Proposed CRT Revisions

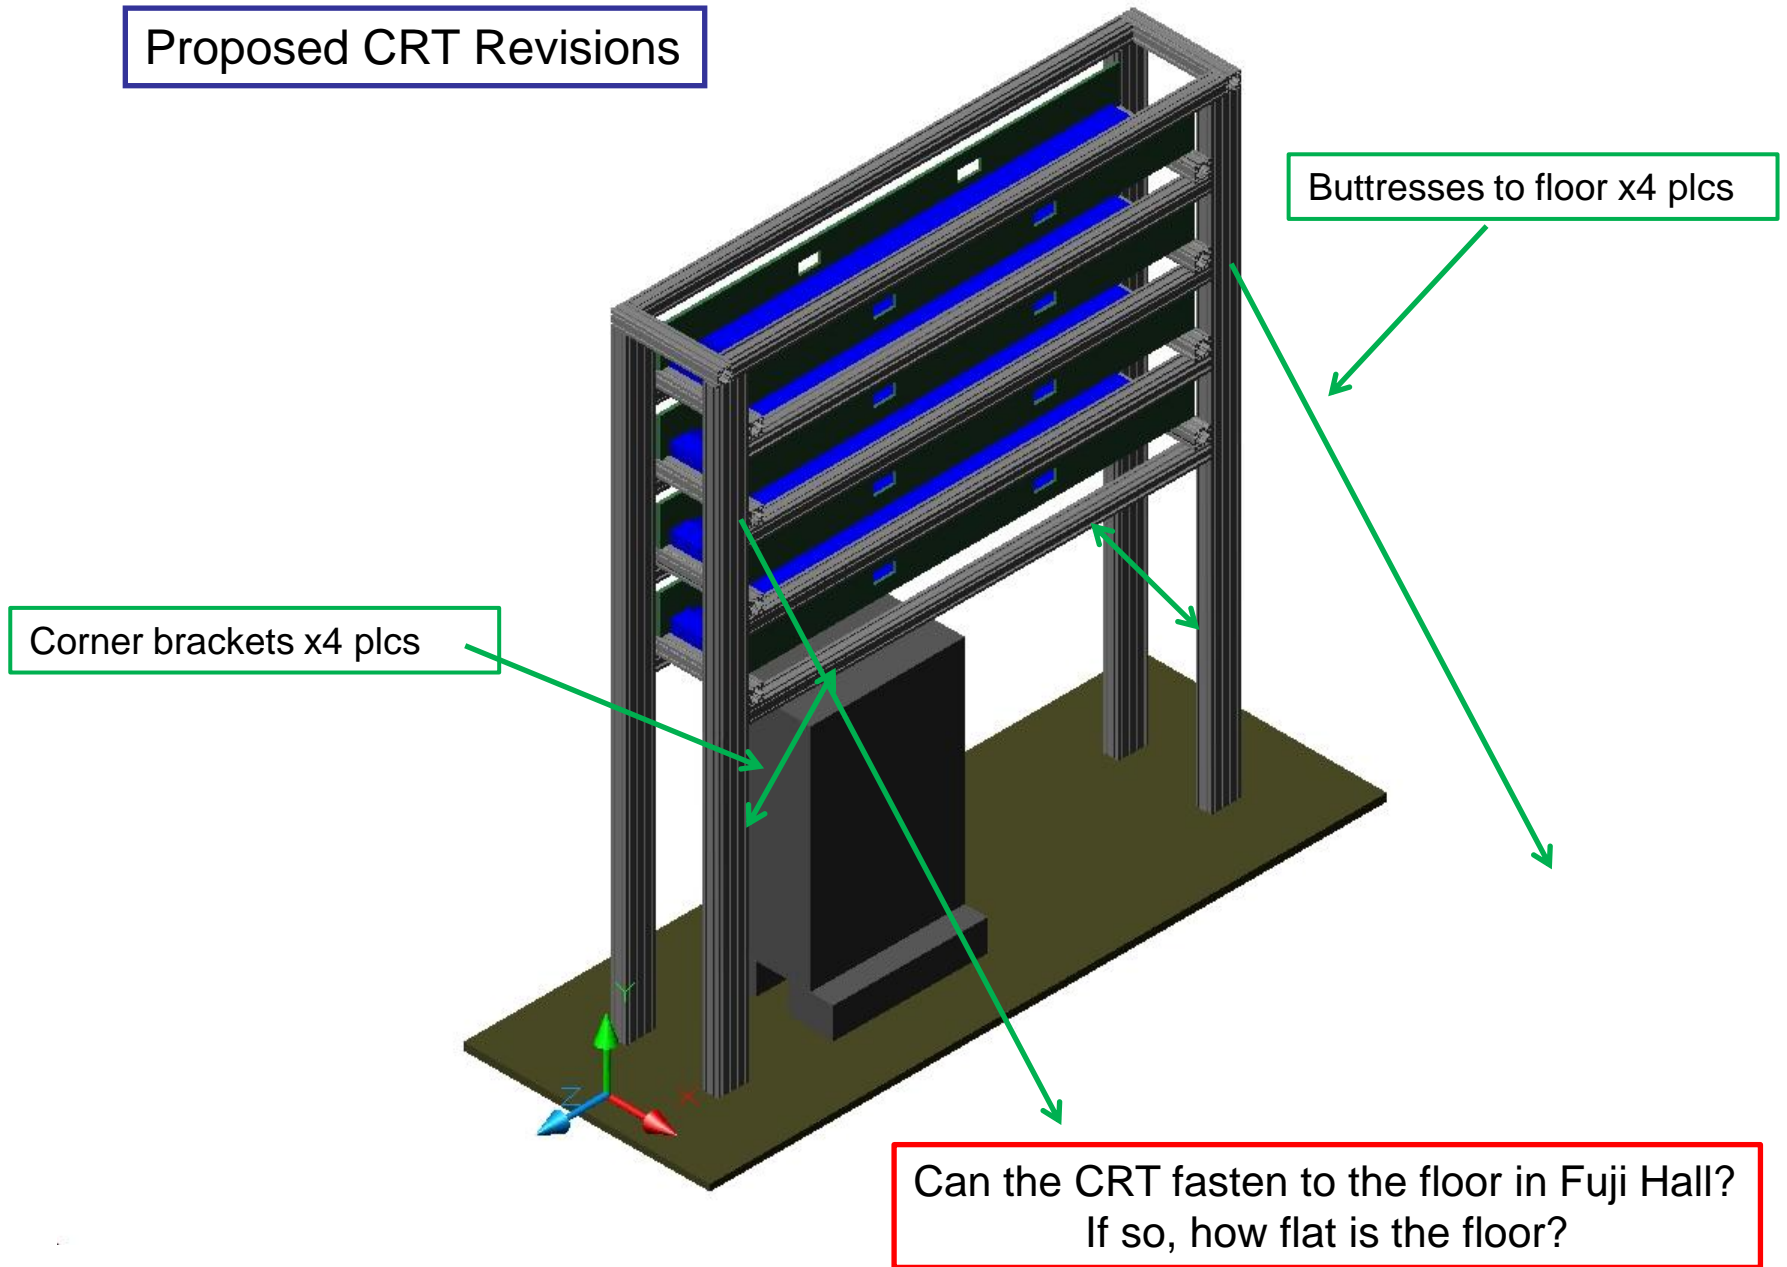
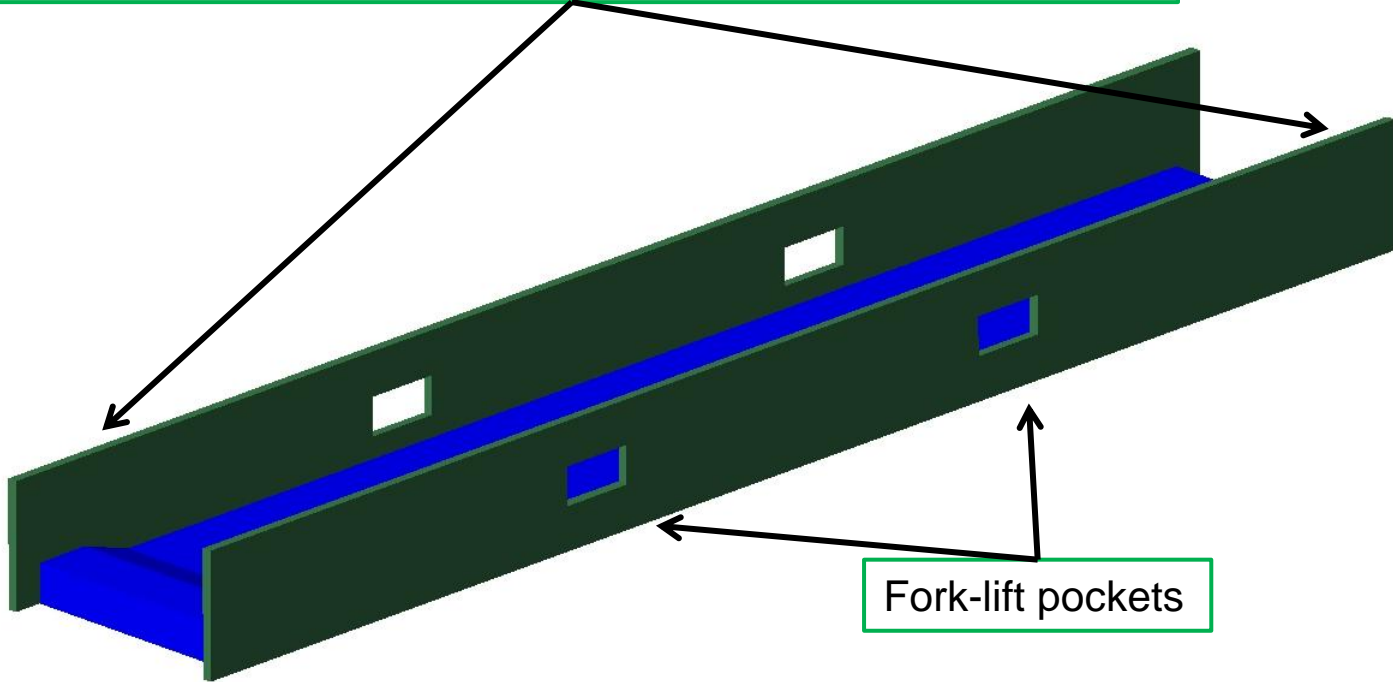
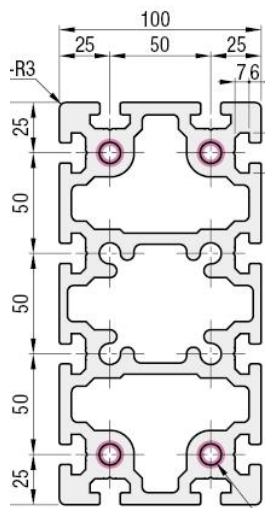
Buttresses to floor x4 plcs

Corner brackets x4 plcs

Can the CRT fasten to the floor in Fuji Hall?
If so, how flat is the floor?

TOP module strong-back for CRT use only

This strong back model is functional in 2cm thick aluminum

Fork-lift pockets

Can the side walls of the QBBs accommodate these strong backs with appropriate mounting holes?

For FEA modeling the two Misumi extrusions shown below will be replaced with equivalent (simple) box beams that have similar properties.
